Re: Interbridges Site, New Brighton Road, Emsworth (LPA ref. APP/24/01010)

Bellamy Roberts has been instructed by PNH Properties to provide a written response to the LLFA's consultation comments dated 17th April 2025, which are enclosed for reference.

Proposed employment development, with associated access, parking, yards and landscaping. at Interbridges Site, New Brighton Road, Emsworth(Application No. APP/24/01010)

Flood Map for Planning

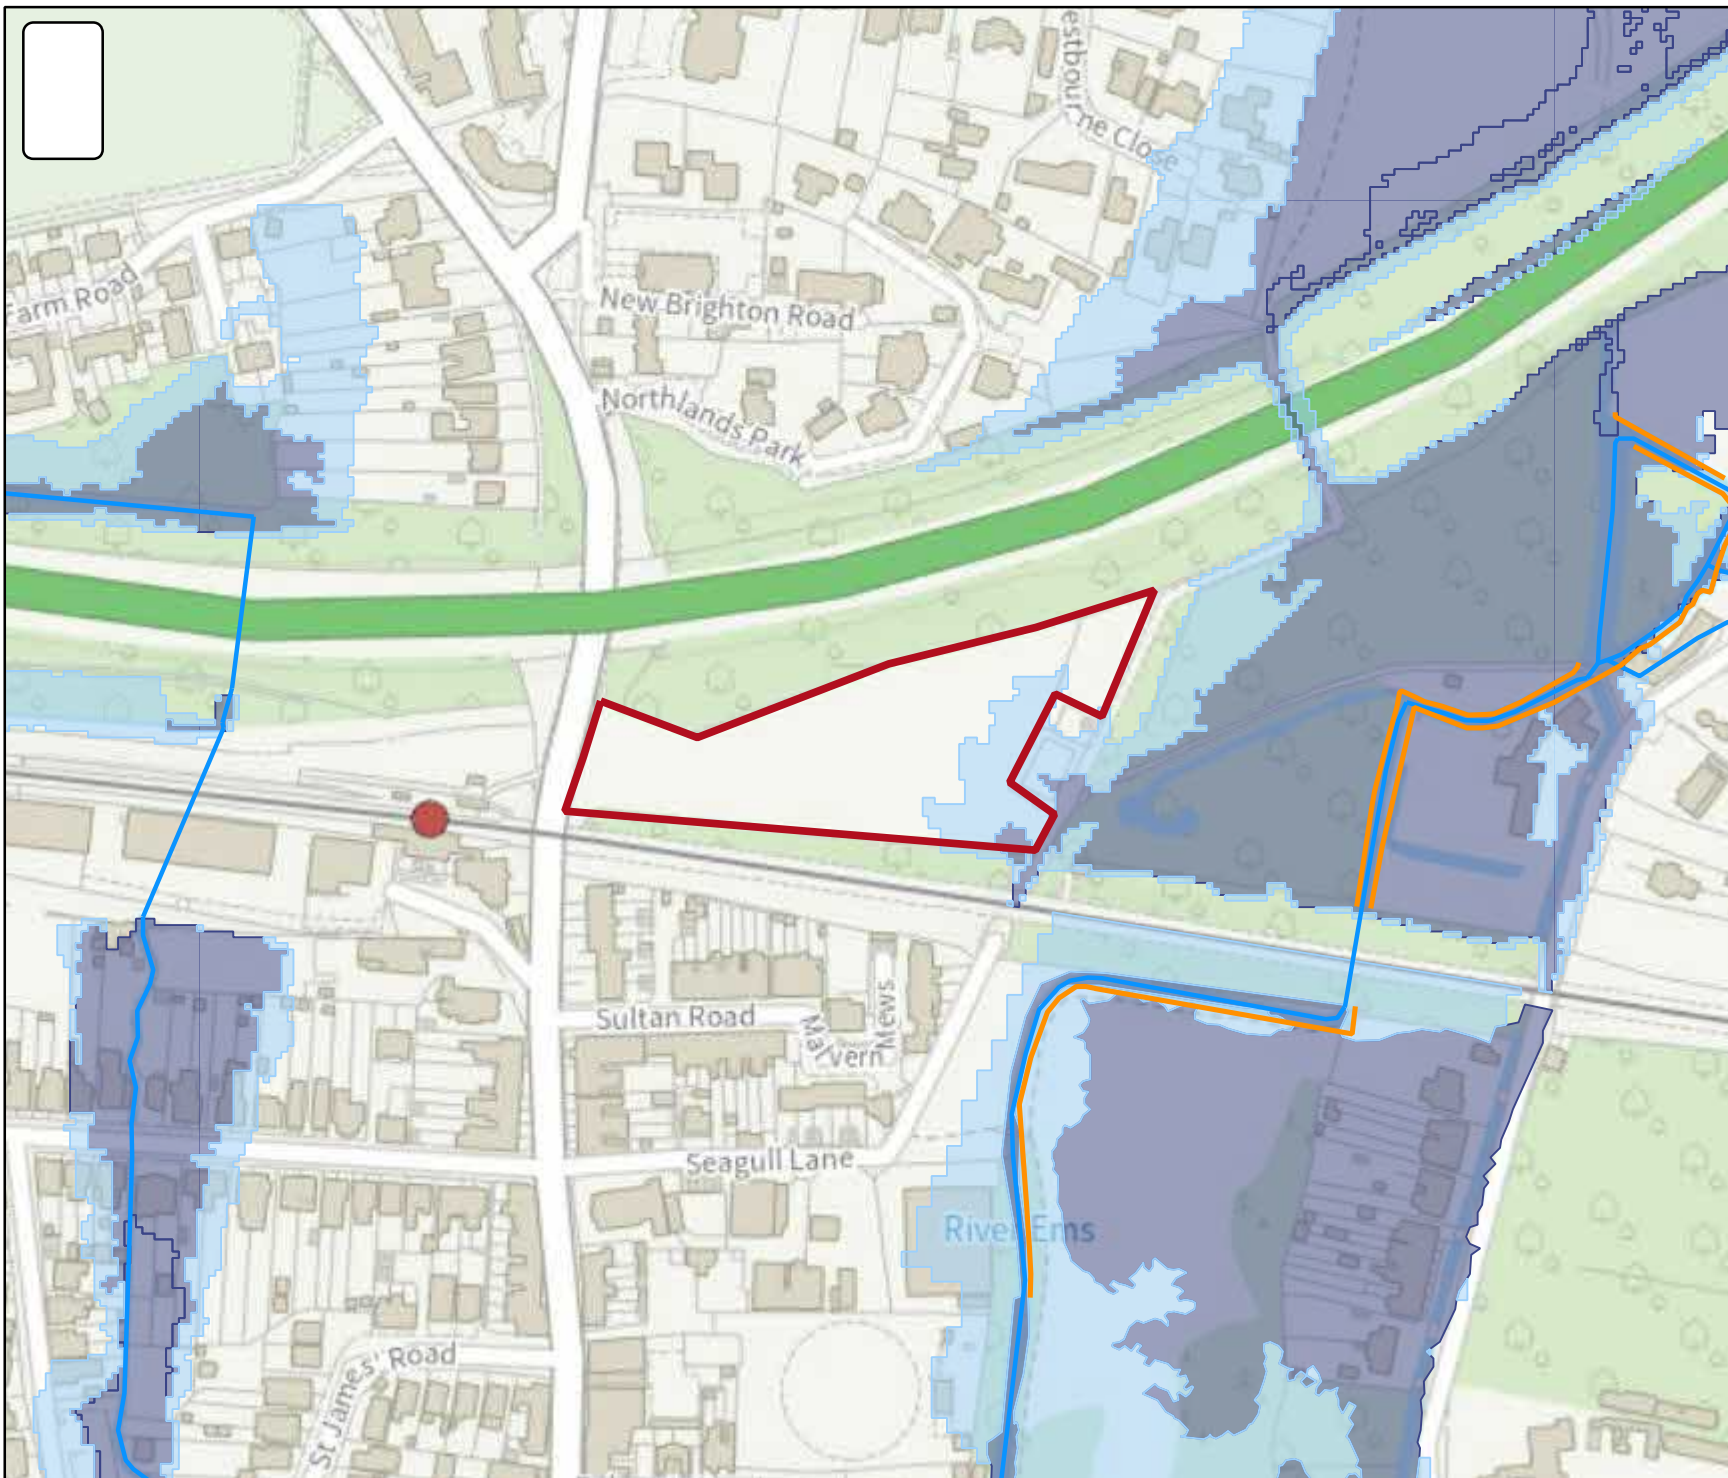
The updated EA flood risk maps are now available to view. The applicant can now update the maps for flood risk from rivers and can assess the implications for the proposed scheme. The updated maps appear to have corrected the discrepancy identified by the applicant in the site flood risk assessment however the maps still indicate part of the site is within flood zone 2 and 3.

We note the changes to the EA maps of flood risk from surface water. Our previous comment regarding development in identified areas of surface water flood risk also apply to areas subject to flood risk from rivers.

The Environment Agency published an updated flood map for planning in March 2025. A copy of this is enclosed for reference.

As stated by the LLFA, the updated mapping has corrected the discrepancy shown on the previous mapping. However, the updated mapping does show that part of the site, towards the eastern and south-eastern boundaries is within flood zone 2. In addition to this, an area within flood zone 3 is shown along the southern boundary, albeit this area is very small.

Site:	Interbridges New Brighton Road Emsworth Hampshire
Project Ref:	P16578
Figure No.	2
Drawing Title	Site Plan
Scale	NTS

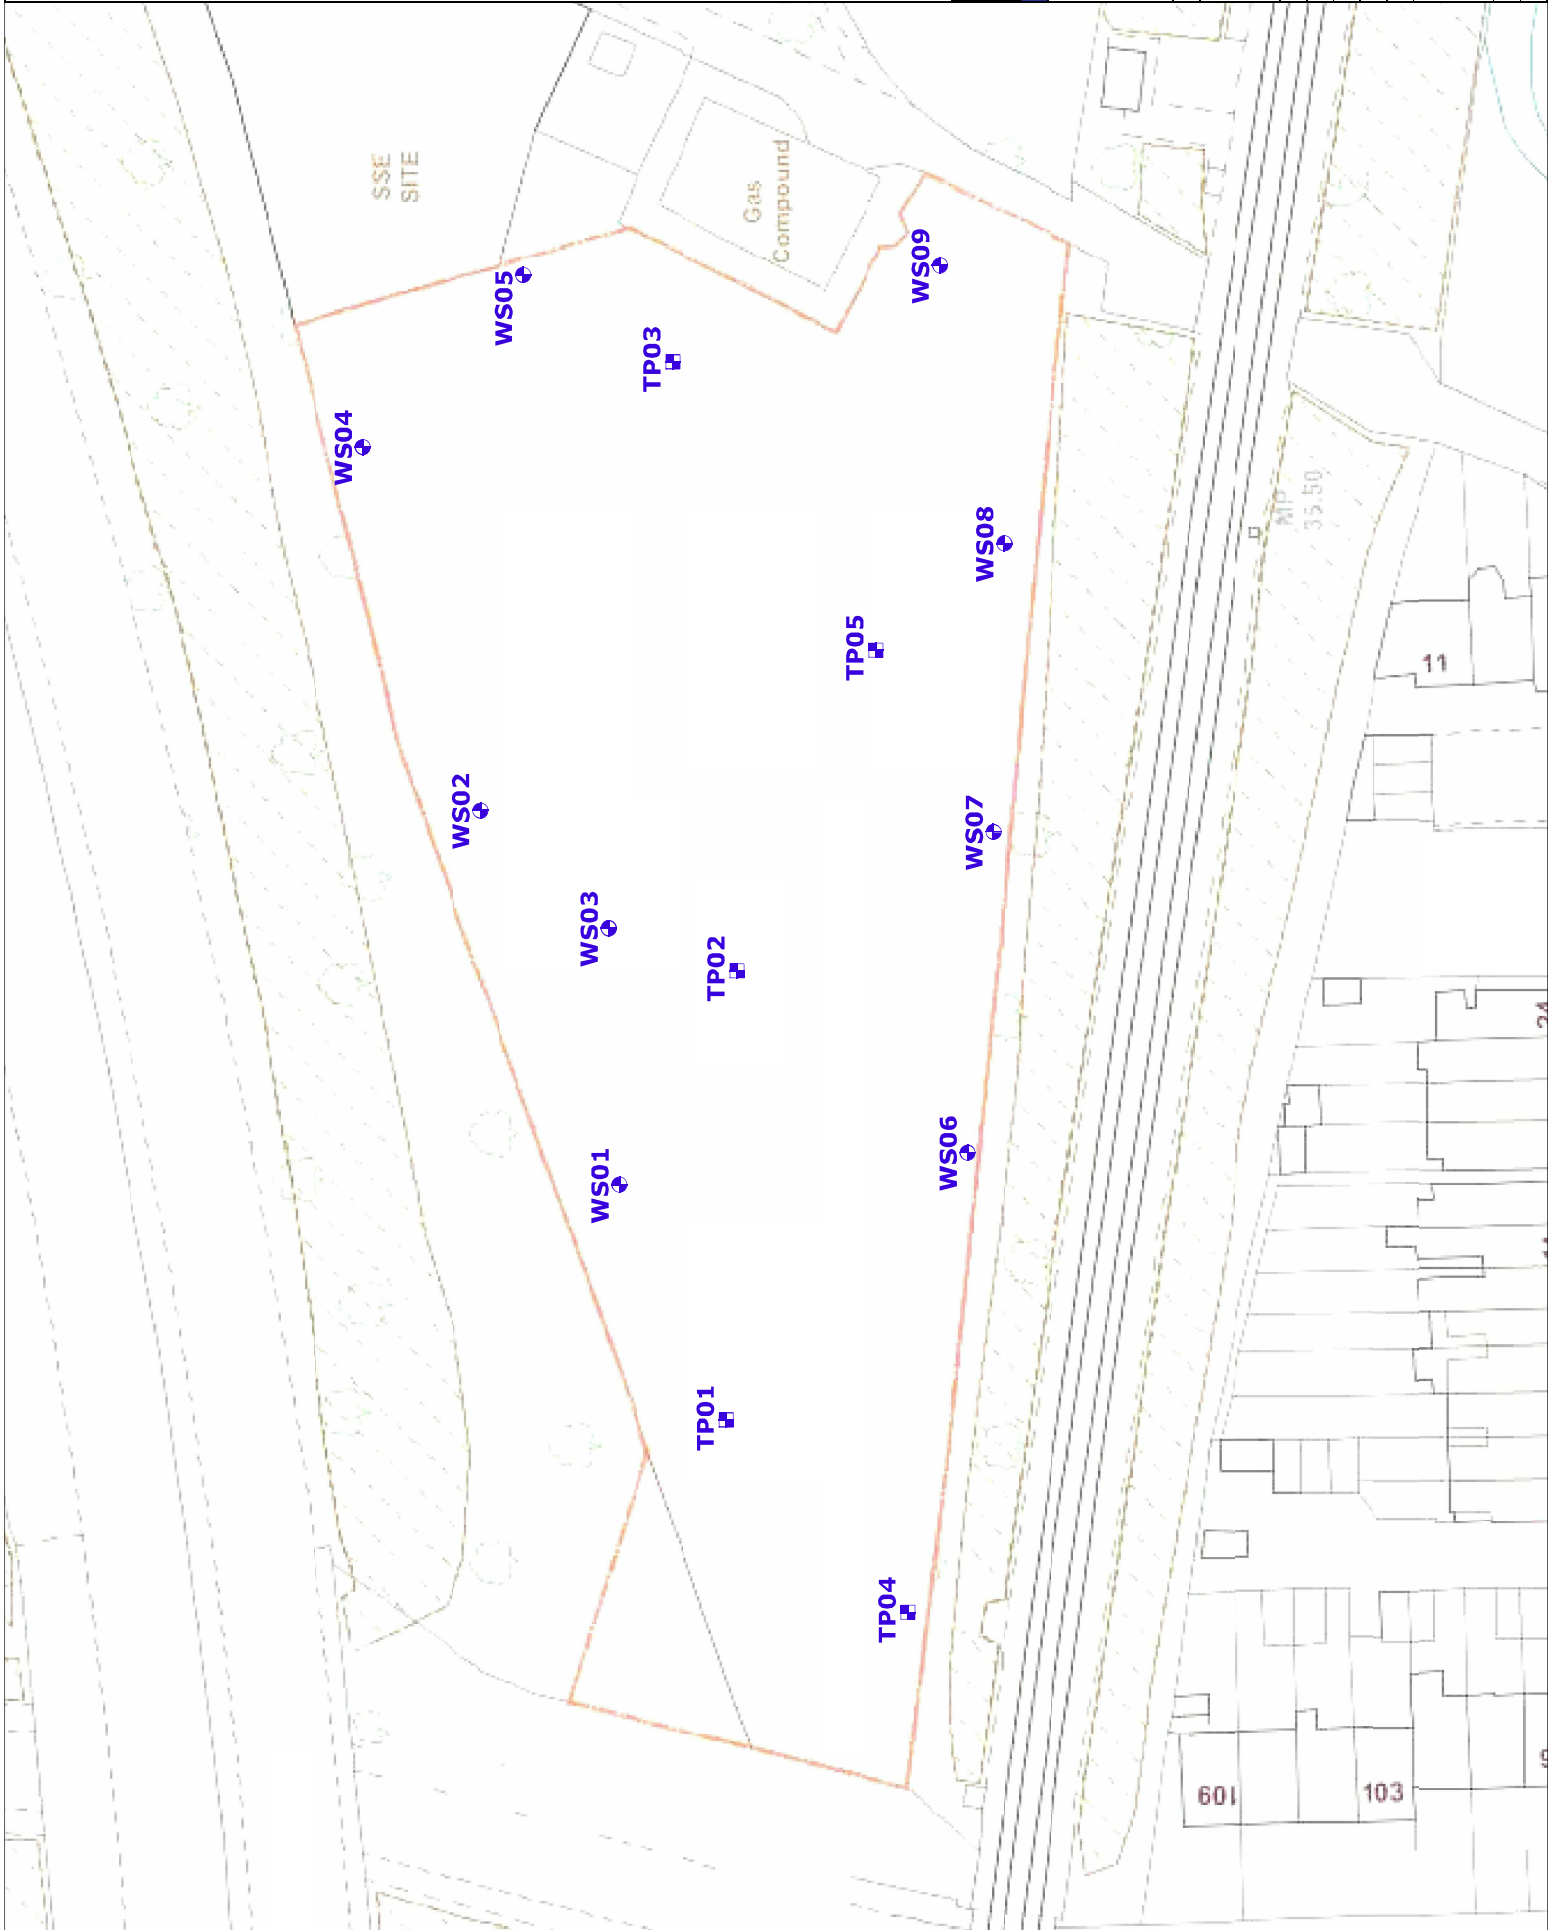
The Lead Local Flood Authority do not agree with the broad assessment of typical groundwater levels described in the above document. Groundwater levels can peak earlier than suggested. As infiltration is not proposed, winter groundwater monitoring could be conditioned by the LPA as the applicant suggests, but, due to the high groundwater levels identified we recommend winter groundwater monitoring is required before granting planning permission.

The plan showing the location of the borehole and results of the groundwater monitoring is not enclosed in the above document as stated(or not available to view).

Extracts from the Ashdown SI Report were presented at Appendix 4 of the Flood Risk Assessment. To assist the LLFA, these extracts including a plan of the testing locations, are enclosed.

The LLFA state that winter groundwater monitoring is required before planning permission is granted. Given that winter monitoring would be undertaken between November and April, and this response is being prepared in May, undertaking such monitoring before the granting of permission would cause unacceptable delays to the process.

It is therefore suggested that this be secured via a Grampian Condition, should this be agreeable to the Local Planning Authority.

TITLE
Drainage Strategy

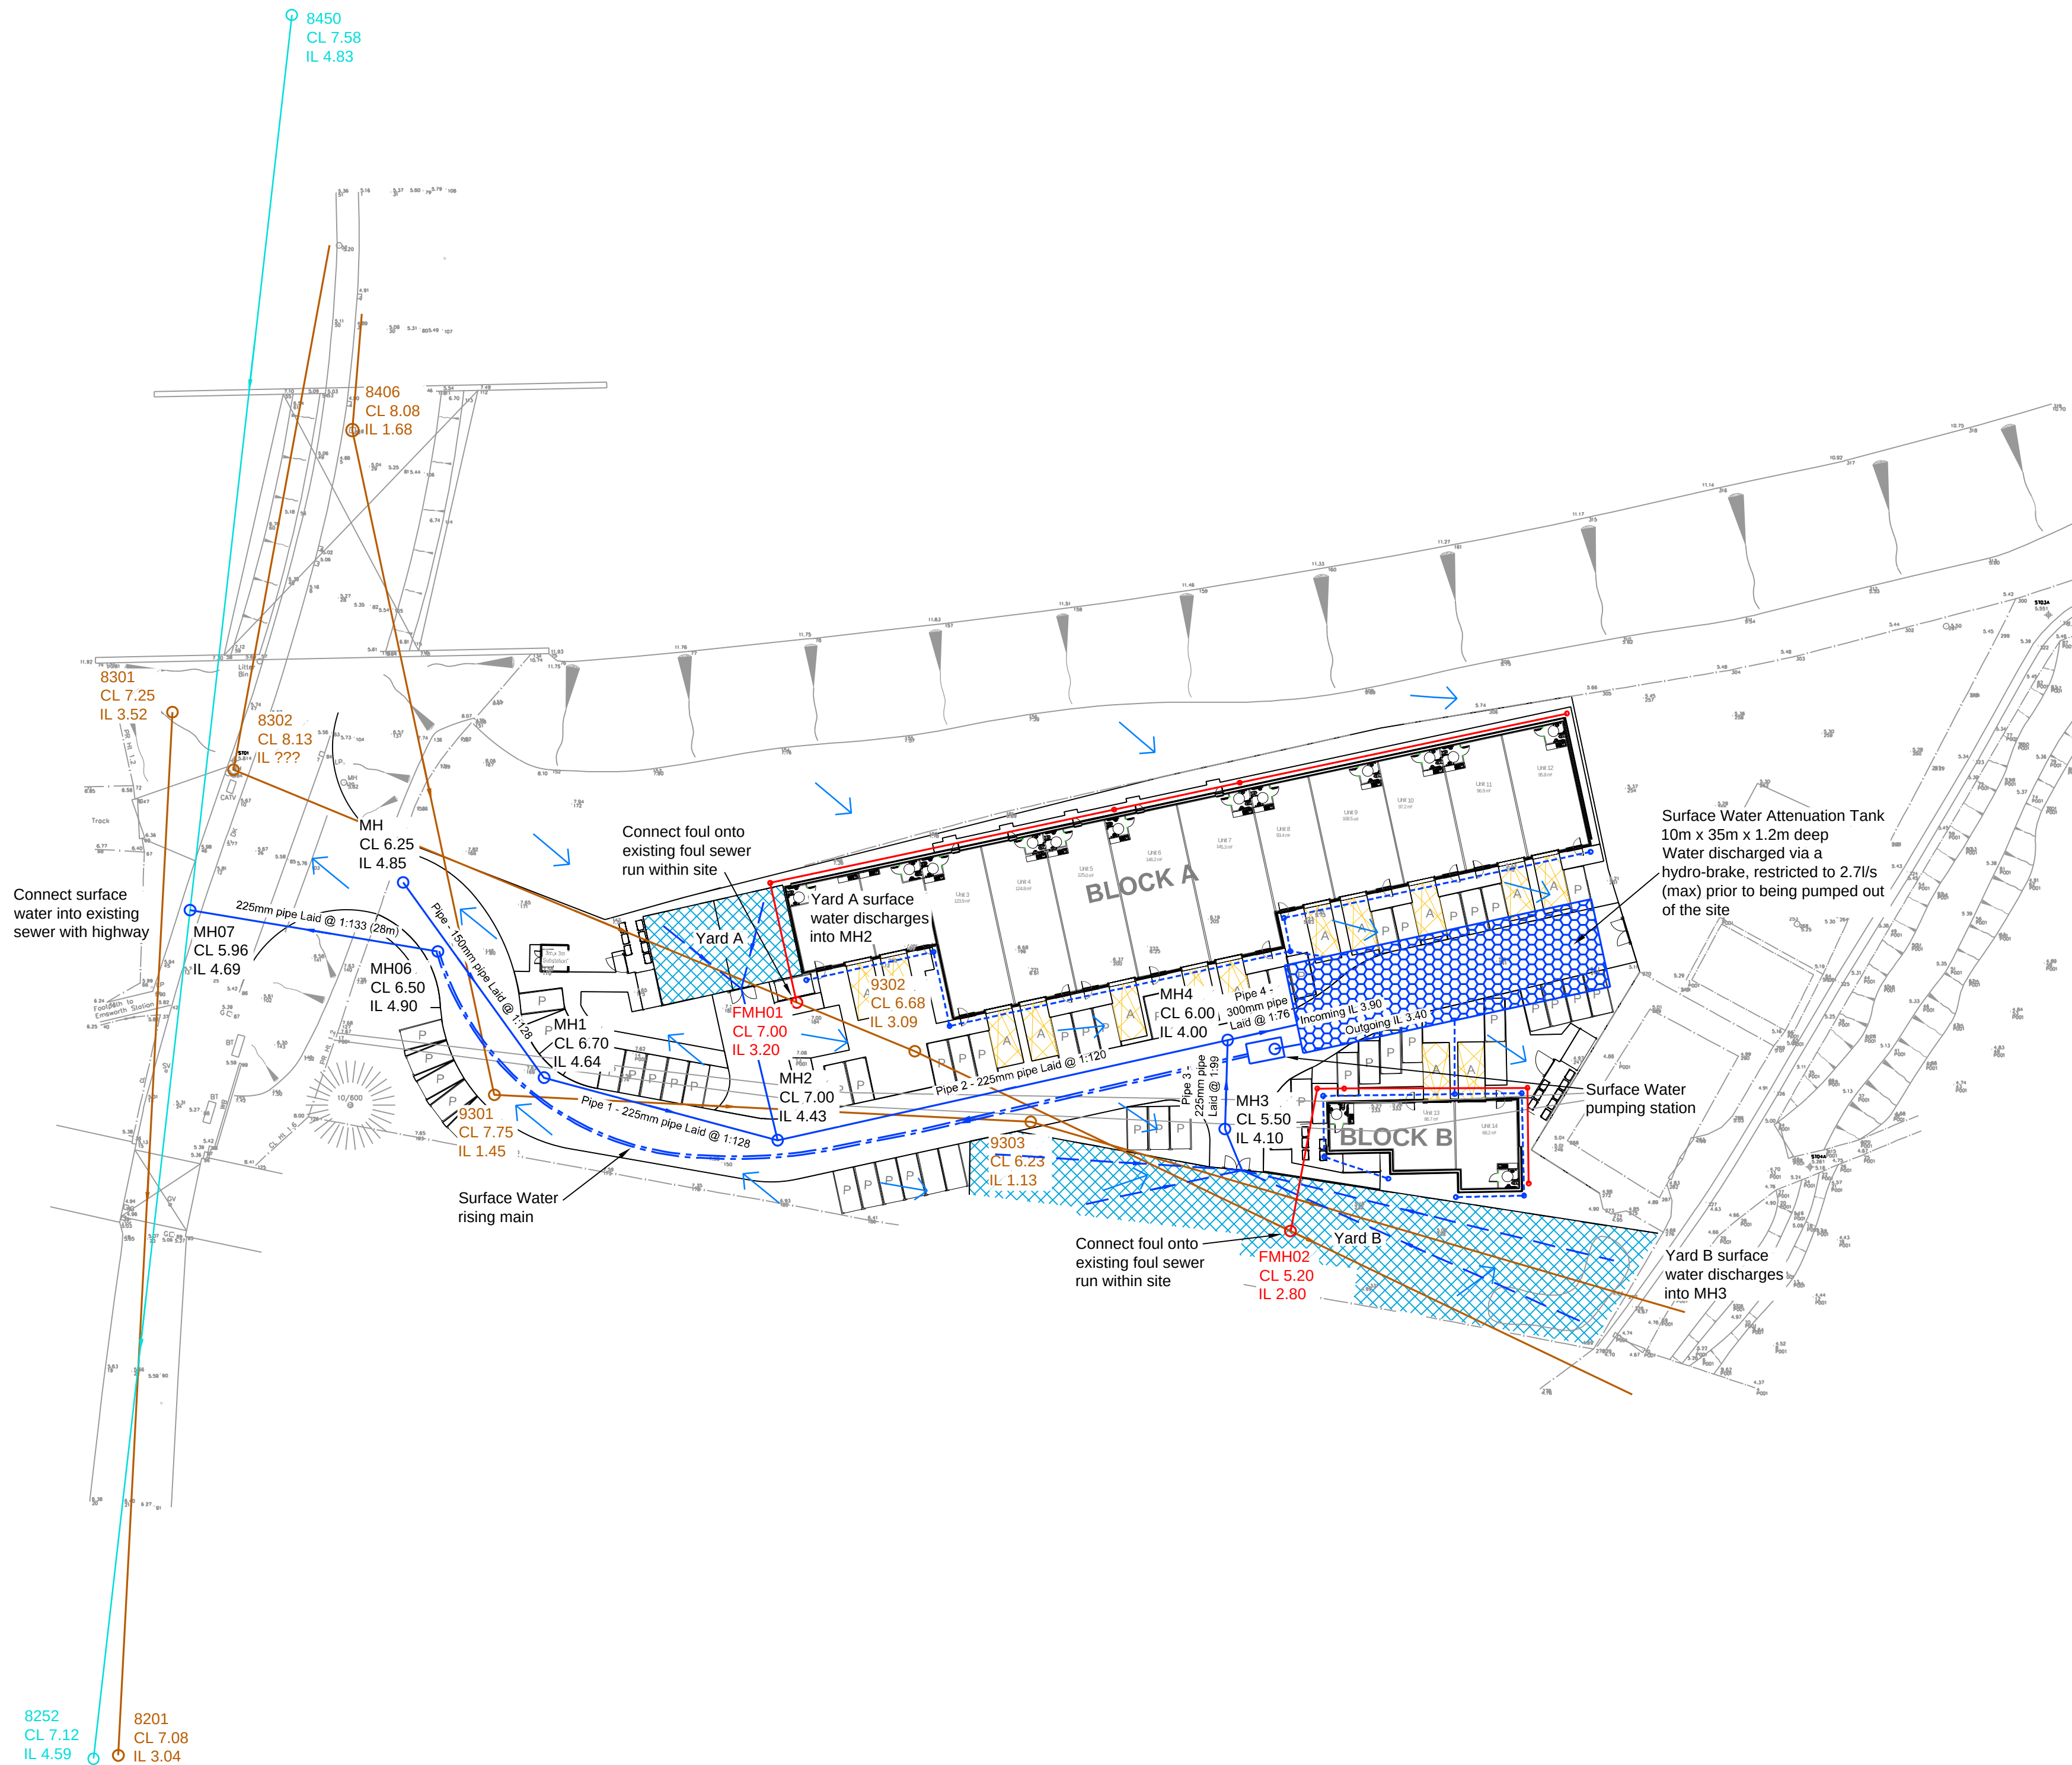
The information provided is sufficient to address our previous comment, however we note the revised proposed surface water drainage strategy plan is not enclosed in the above document as stated (or not available to view).

Comments are noted. We await submission of amended drainage drawing for review.

We await submission of the external levels plan.

A copy of the revised surface water drainage strategy is enclosed.

The amended surface water drainage strategy shows the routing of the proposed perforated pipes within the open yard areas.

To assist, the proposed surface water drainage strategy incorporates proposed levels.

**Cellular Storage**

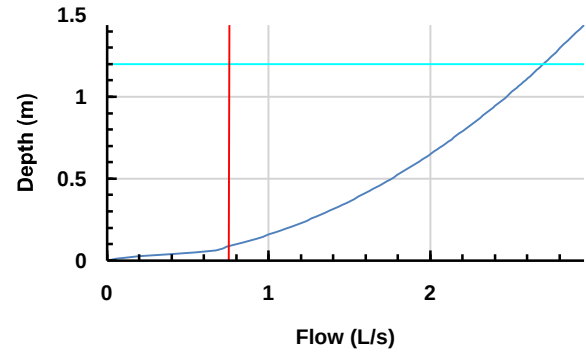
We await submission of the network model for review. We previously commented that it is not appropriate to model a pump as if it were a hydrobrake as was in the previously submitted hydraulic calculations. This is because the discharge characteristics of the two features is different. The hydraulic calculations submitted previously are not considered to be representative of the design and therefore the table of existing and proposed discharge rates at the end of the above document is also not considered to be applicable.

The network model has been developed using the Infodrainage software and this is enclosed.

The discharge rate from the attenuation tank will be restricted via a hydrobrake prior to being pumped to the surface water sewer.
